TSGR1#9(99)i49

Title: CR 25.211-010: Updates to AICH description

25.211	CR	010	Current Version:	3.0.0

Subject: Update to AICH description

Figure 21: Structure of Acquisition Indicator Channel (AICH).

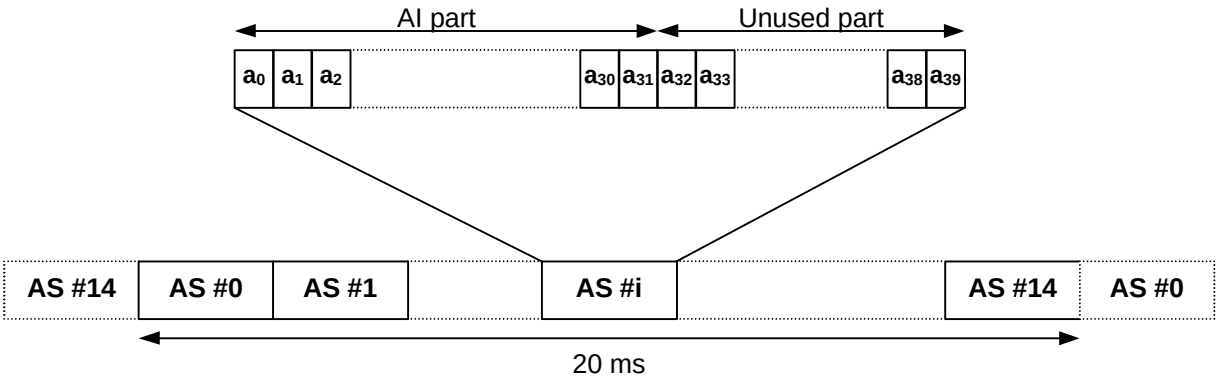
- Each AS is described as consisting of 40 real symbols instead of 20 complex symbols. The reason is that the spreading description of 25.213 assumes that a physical channel to be spread consists of real-valued symbols.

- The “two frames” in Figure 21 is removed. It is not clear what these “frames” refers to. It does not seem to be necessary to define an *AICH frame*.
- The description of the generation of the AICH is moved from 25.213 to 25.211. The reason is that this description deals with the generation of non-spread AICH symbols and does not seem to be related to spreading.

- It is clearly specified that the value of unused symbols is undefined. In this way, future usage of these symbols is possible. This would not have been possible if they had been specified as zero.

Figure 21 illustrates the structure of the AICH. The AICH consists of a repeated sequence of 15 concecutive *access slots* (AS), each of length 40 bit intervals. Each access slot consists of two parts, an *Acquisition-Indicator* (AI) part consisting of 32 real-valued symbols a_0, …, a_{31} and an unused part consisting of 8 real-valued symbols a_{32}, …, a_{39}.

The real-valued symbols a_{32}, a_{33}, …, a_{39} in Figure 21 are undefined.
